# UNITED STATES PATENT AND TRADEMARK OFFICE

| APPLICATION NO. | FILING DATE | FIRST NAMED INVENTOR | ATTORNEY DOCKET NO. | CONFIRMATION NO. |
|-----------------|-------------|----------------------|---------------------|------------------|
| 10/776,085      | 02/11/2004  | Dilip Tapadiya       | TAPADI.003C3        | 2366             |

| <b>Office Action Summary</b> | <b>Application No.</b> | <b>Applicant(s)</b> |  |

## **DETAILED ACTION**

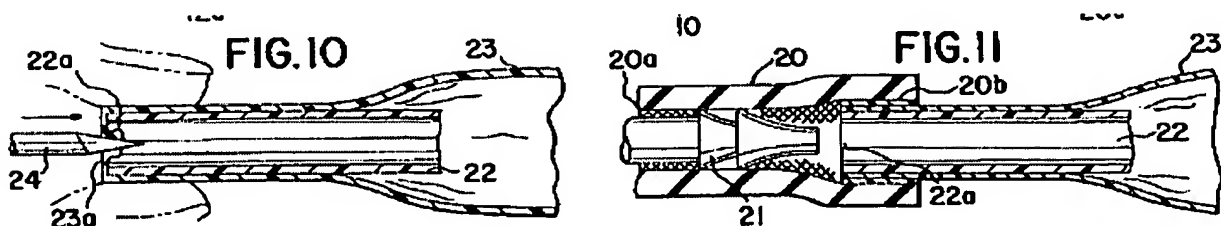
Regarding claim 127, Bryan *et al.* teach a medical hose kit comprising a sterilized package (23) containing a sterilized length of hose (10, 22), the hose (10, 22) having first and second hose ends, a first hose outer diameter and a first hose inner diameter, at least a first connector (20) disposed at the first end, the first connector (20) having a first connector end (20b) defining first connector inner diameter, a second connector end (20a) defining a second connector inner diameter, and a partition (21) disposed between the first and second ends and defining a third connector inner diameter that is smaller than both of the first and second inner diameters, the first connector inner diameter being about the same as the first hose (10, 22) outer diameter such that the first end of the hose fits into the first connector end (20b), the second connector inner diameter being smaller than the first connector inner diameter (column 4, lines 30-48)(see figure 11, below).

Applicant's arguments filed 08 February 2006 have been fully considered but they are not persuasive. Applicants assert that Bryan *et al.* do not teach a suction hose and a connector with first, second and third inner diameters. Regarding the "suction hose" limitation, see col. 1, lines 56-57. Regarding the first, second and third inner diameters, see the enumerated rejection of claim 127, *supra*, and figure 11.

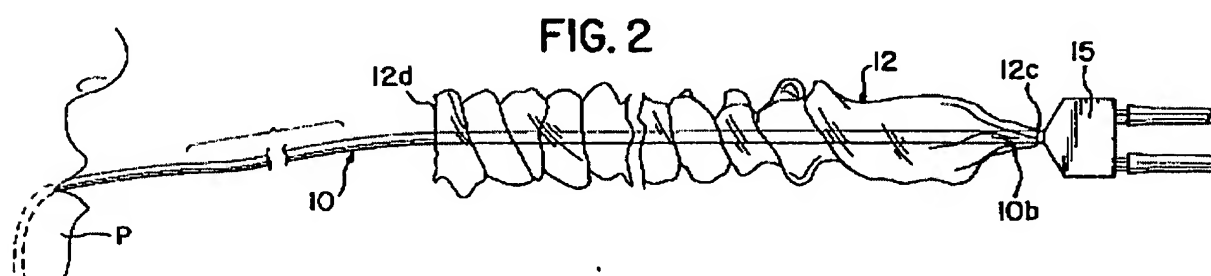
Regarding claims 131-133, Bryan *et al.* teach that the first connector (20, 21) is connected to a suction device that may be held by hand (10)(see figure 2, below).

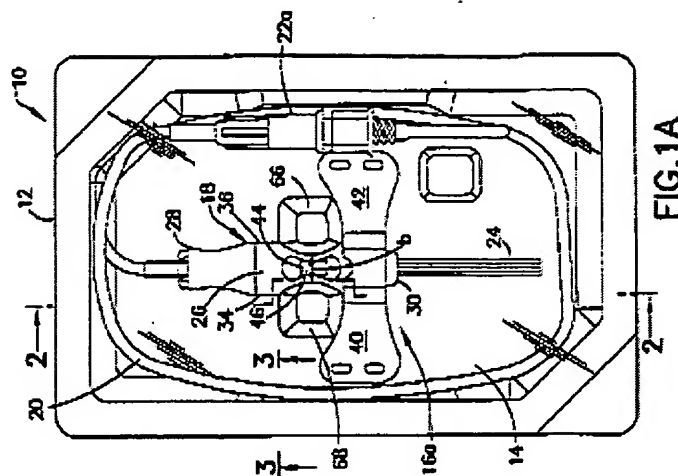
Giard, Jr. *et al.* teach packaging (12) for a medical collection device that includes a coiled tube (20)(see figure 1A, below).

At the time of the invention, it would have been obvious to one of ordinary skill in the art to adopt the coiled tube configuration of Giard, Jr. *et al.* for the kit of Bryan *et al.* in order to provide a compact kit size for storage.
